INDEX OF STRUCTURAL DRAWINGS

STATE OF HAWAII DEPARTMENT OF TRANSPORTATION HIGHWAYS DIVISION. INDEX OF STRUCTURAL DRAWINGS. INTERSTATE ROUTE H-1 AND H-201 DESTINATION SIGN UPGRADE/REPLACEMENT, PHASE 3B. FAP NO. NH-0300(205). Scale: None Date: Oct. 2023 SHEET No. S1.1 OF 5 SHEETS

EXTERIOR BARRIER REINFORCING ELEVATION
 Scale: 1/2" = 1'-0" A
S5.8 | S5.8

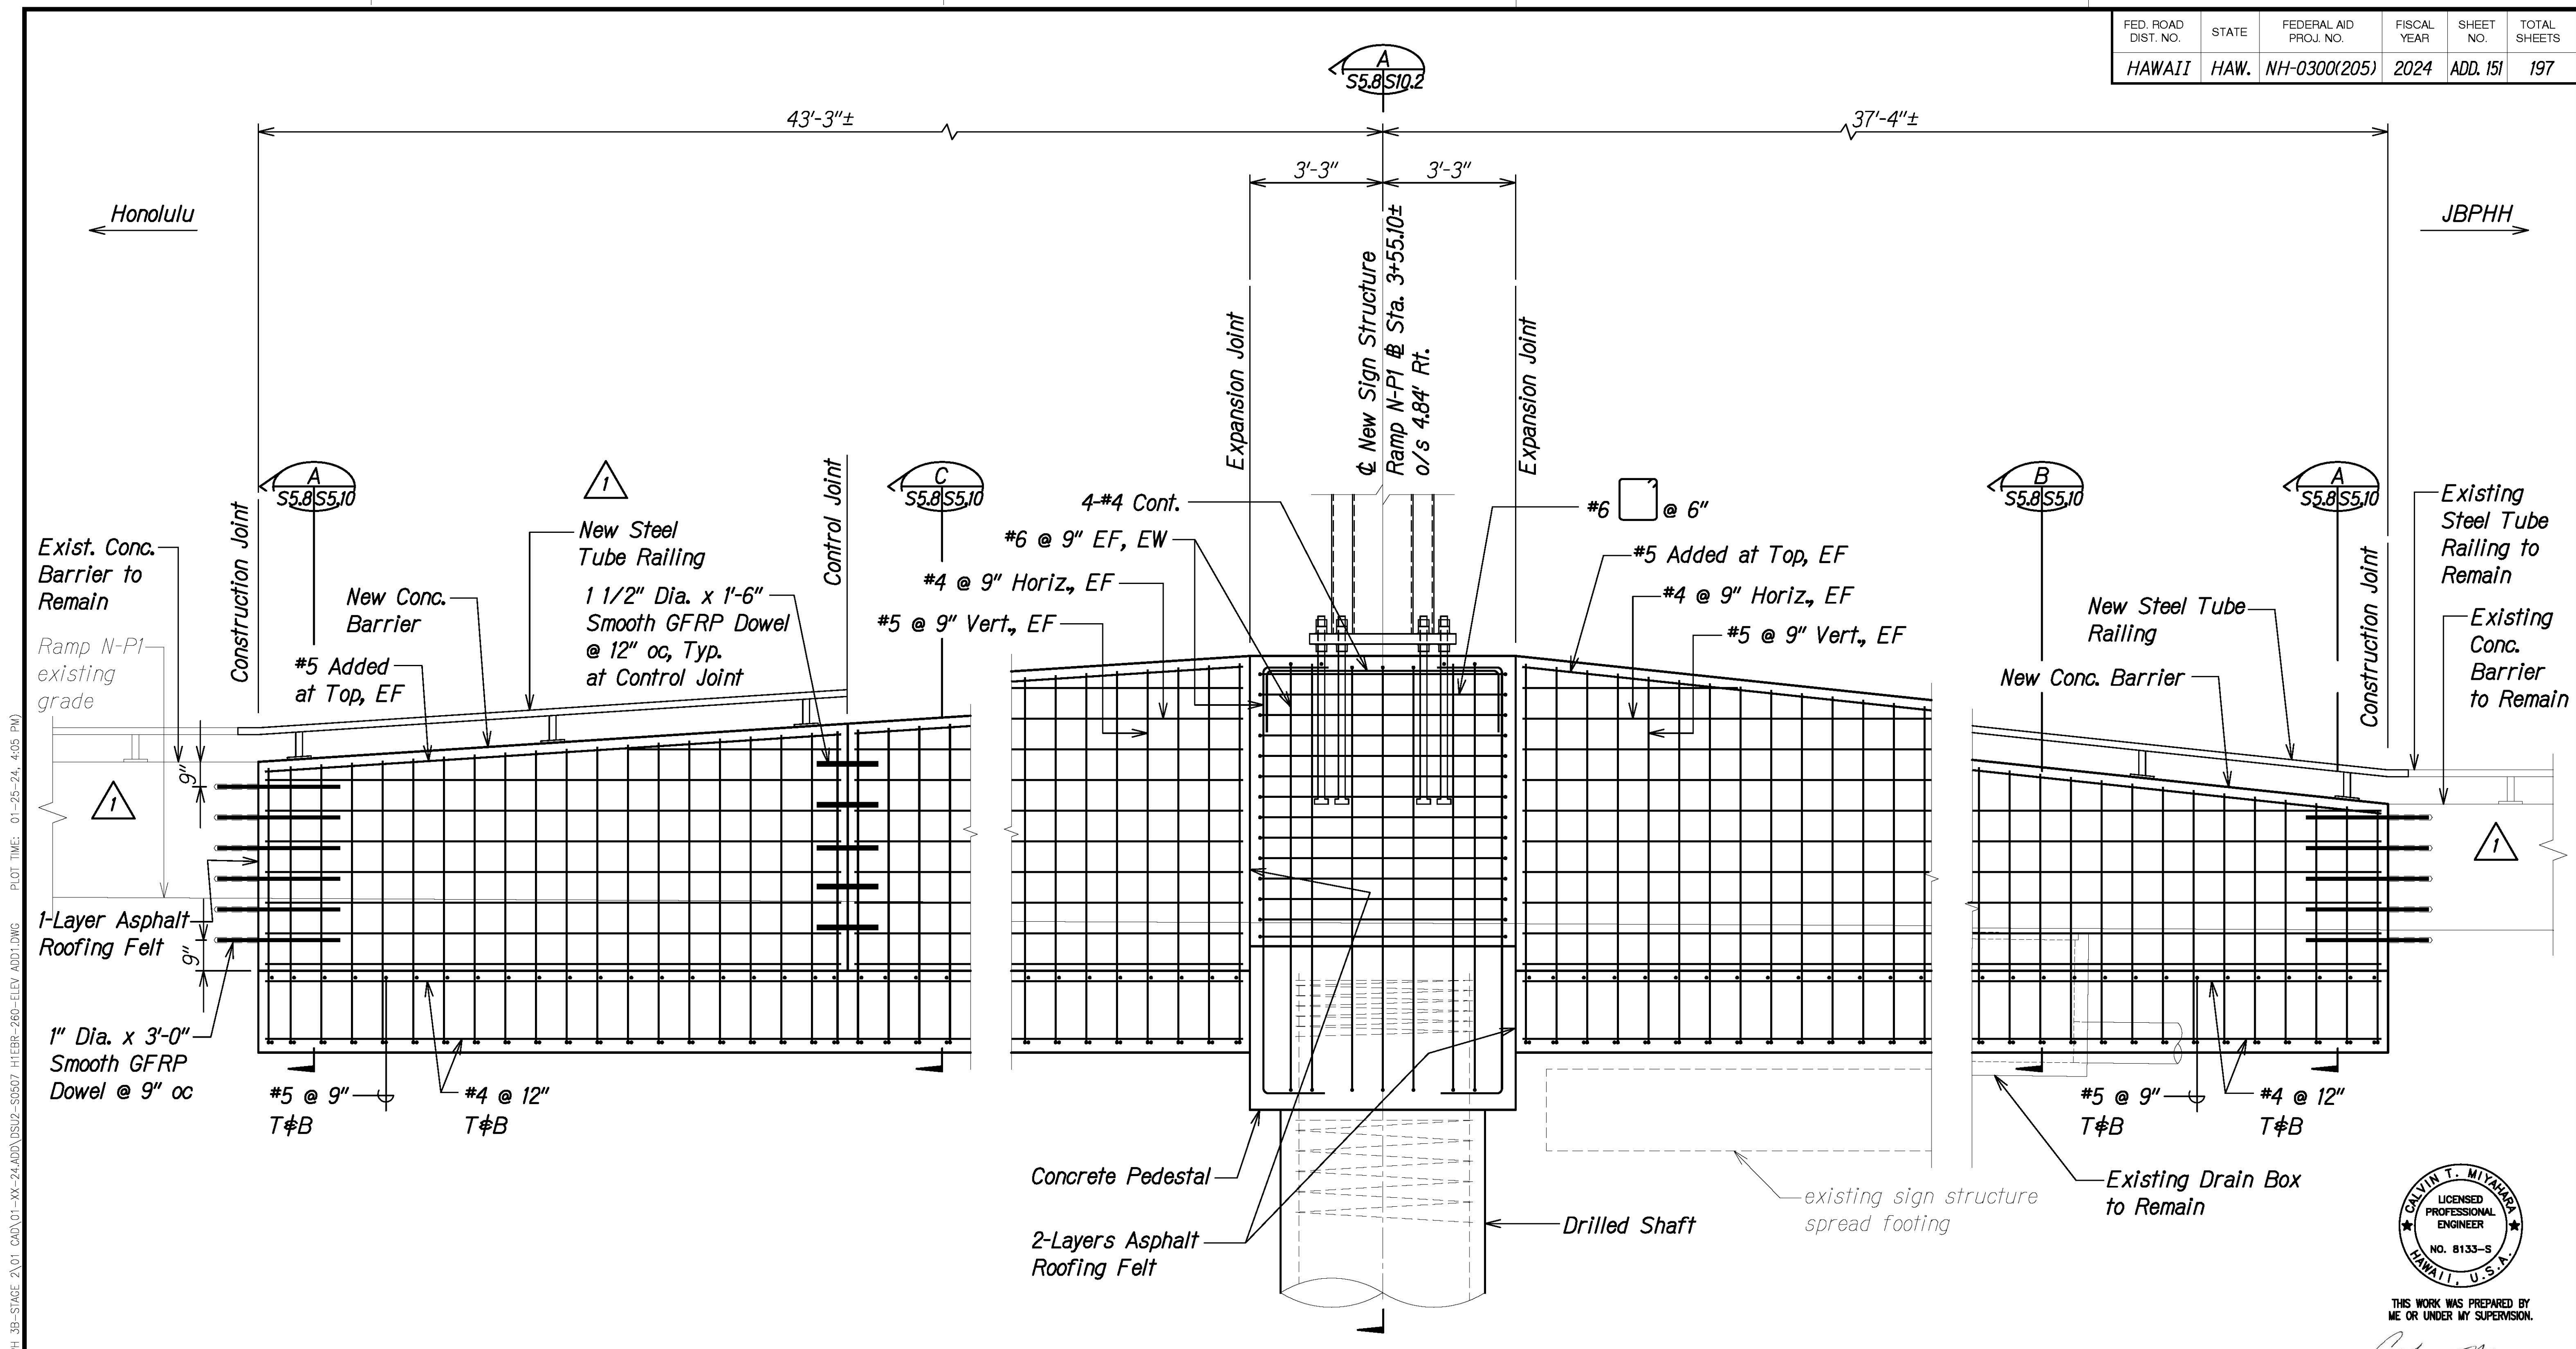
DATE	1/25/24	REVISION	1 Add. 1 - Revised Details
------	---------	----------	----------------------------

NEW SIGN STRUCTURE 78WB-853 ELEVATION
 Scale: 1/4" = 1'-0"
 A
 S7.1 | S7.1

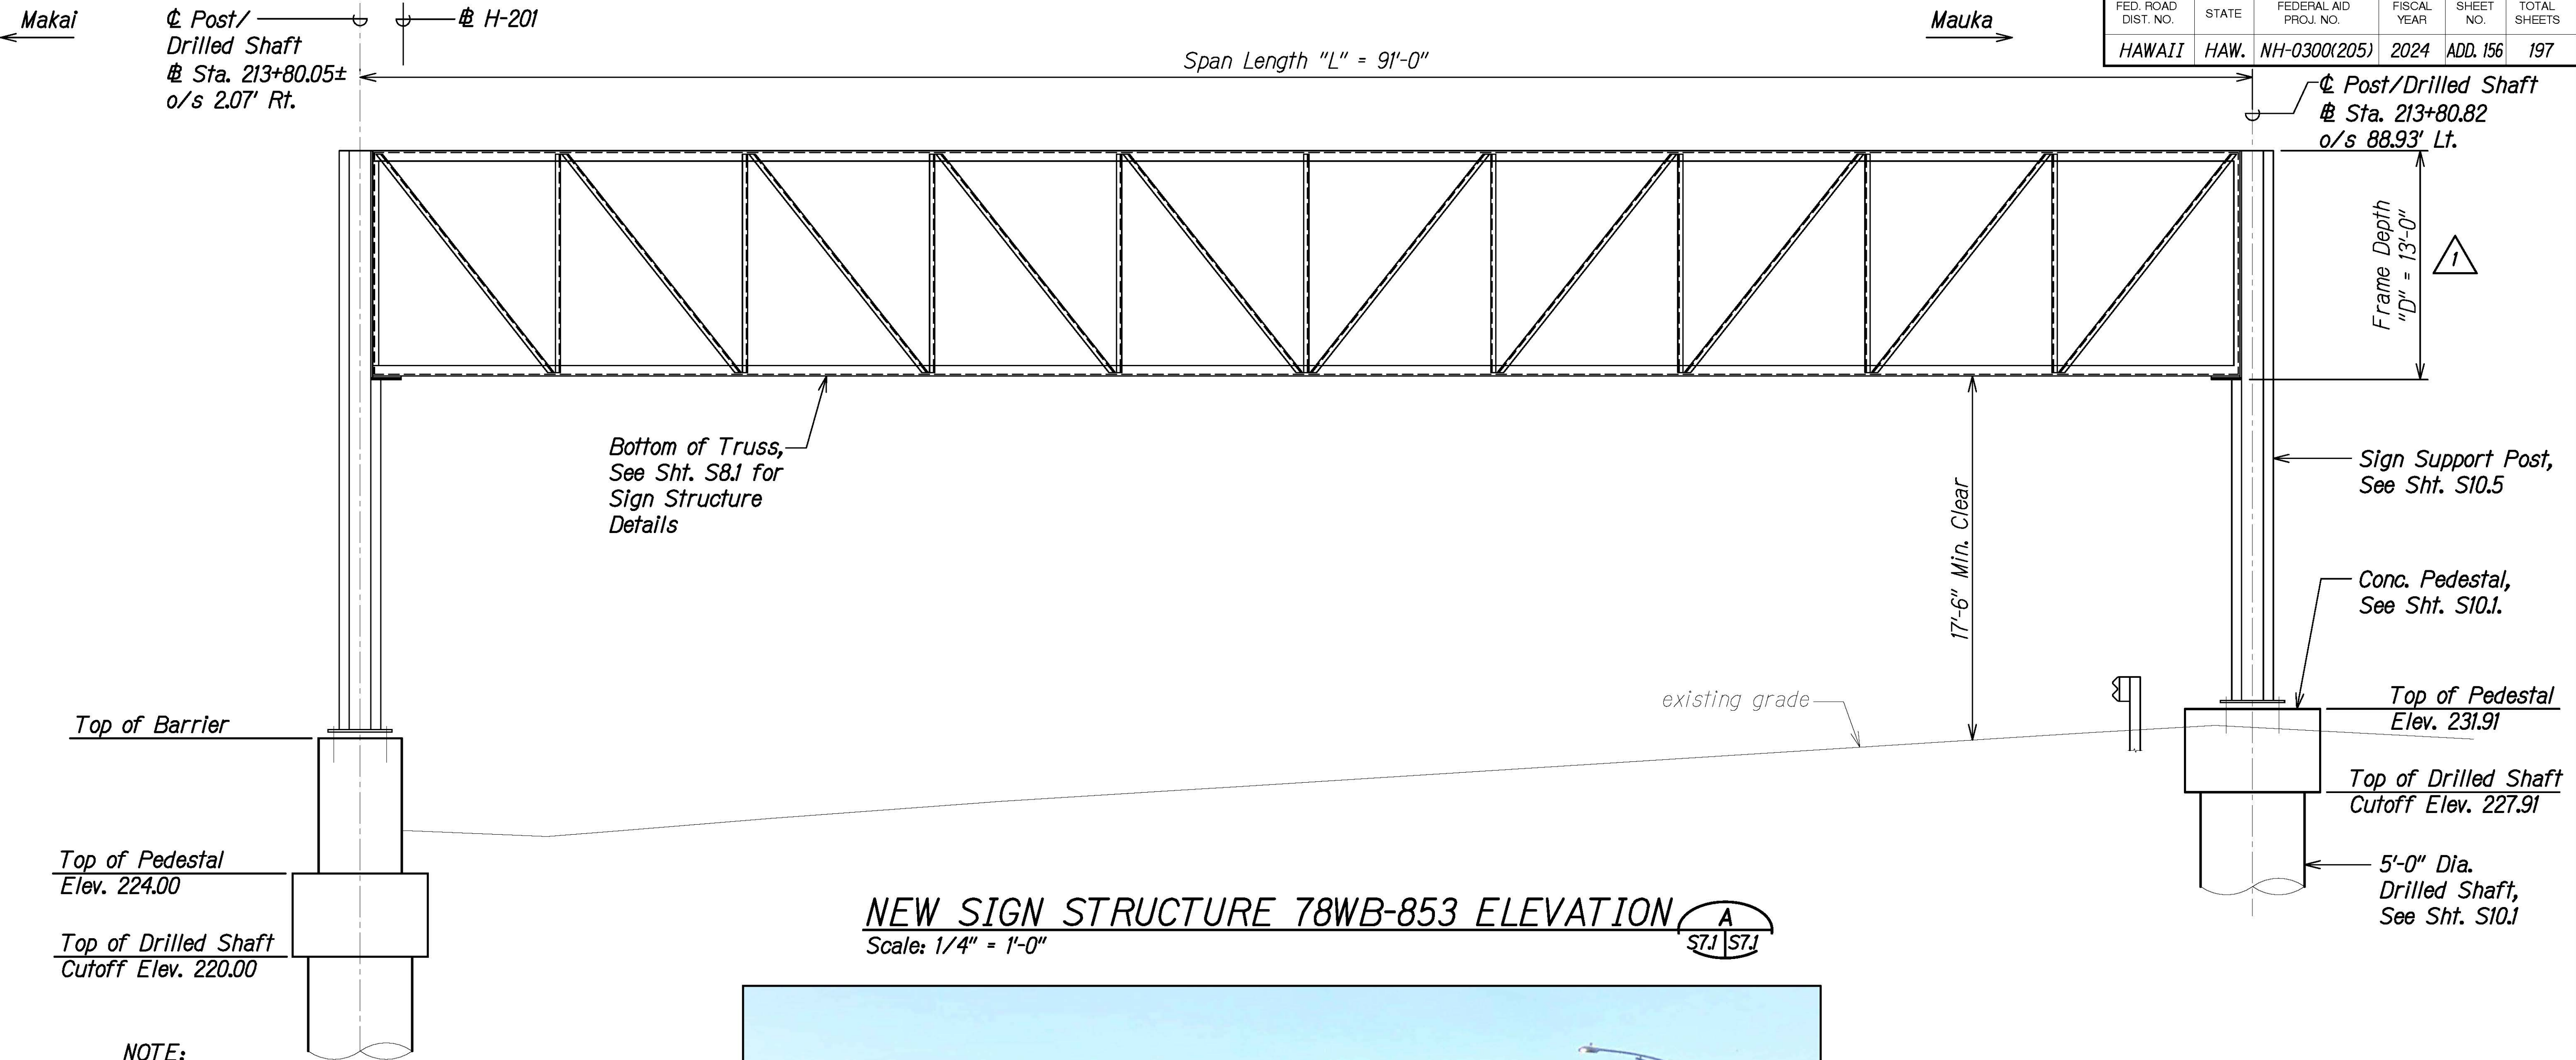
DATE	REVISION
1/25/24	1 Add. 1 - Revised Dimension

**BOX TRUSS SIGN STRUCTURE
 PLAN AND ELEVATION**

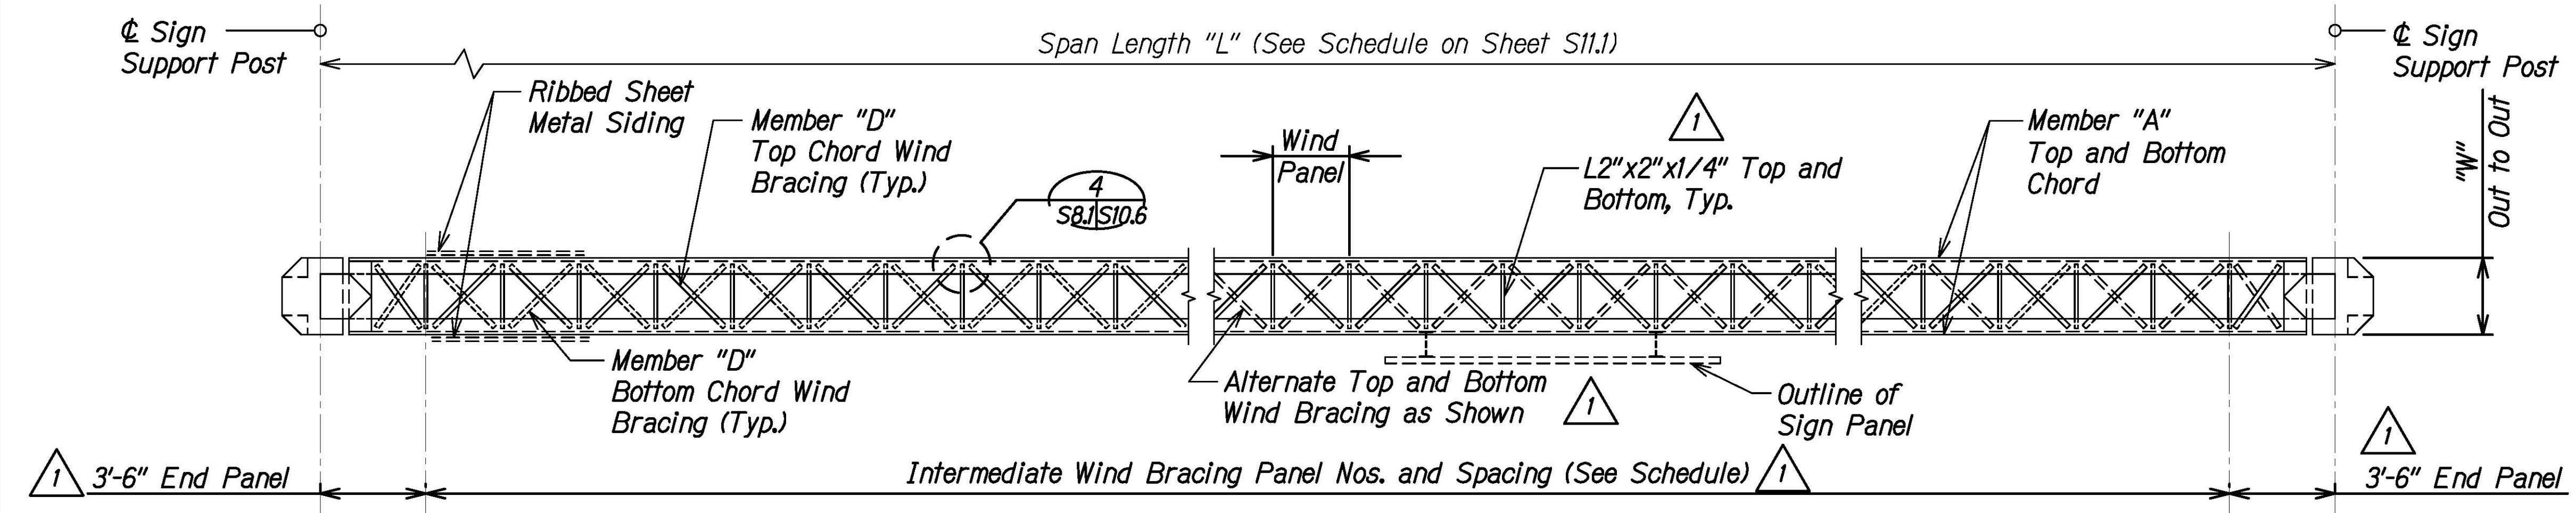
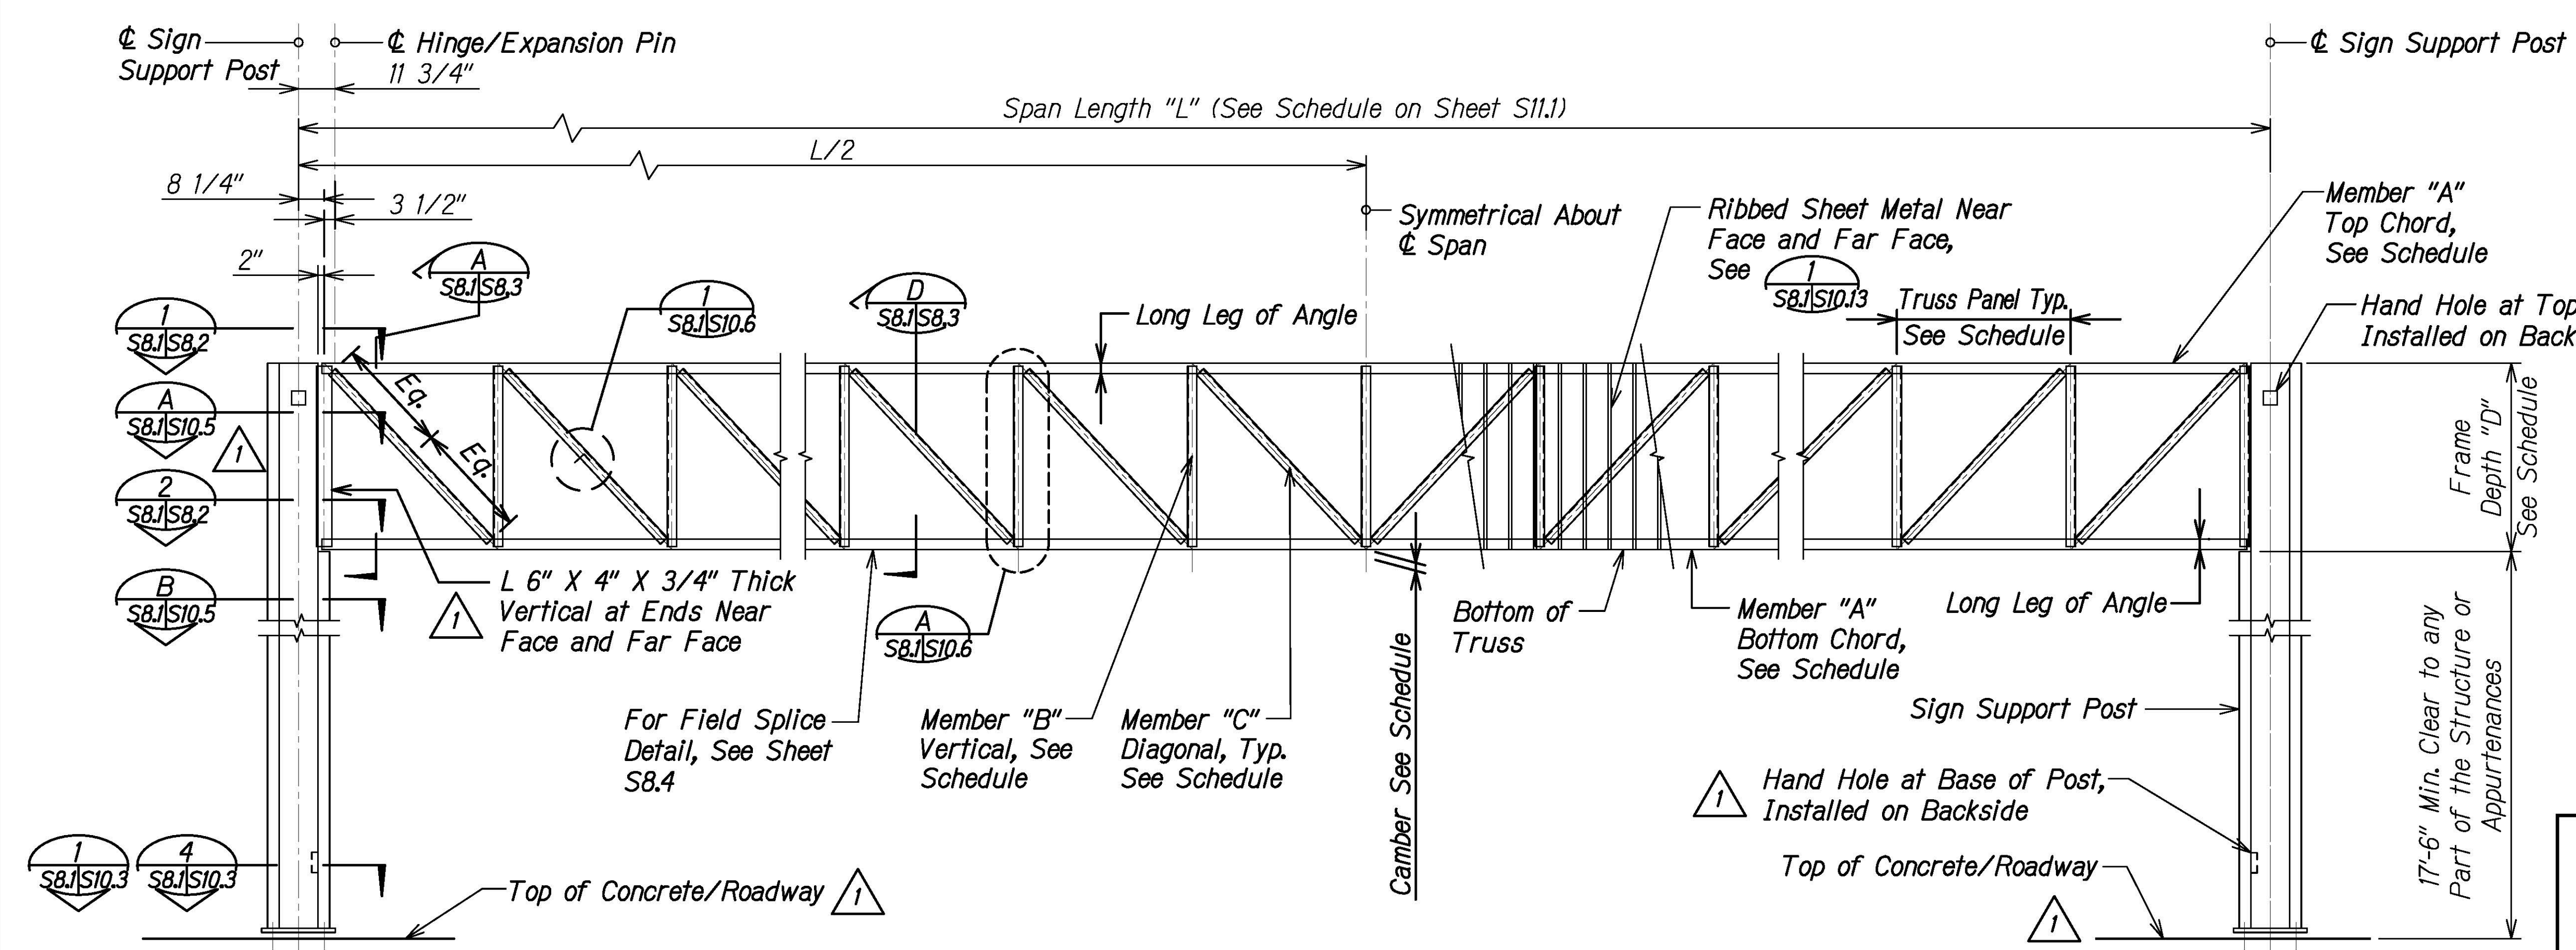
DATE	REVISION
1/25/24	1 Add. 1 - Revised Callouts
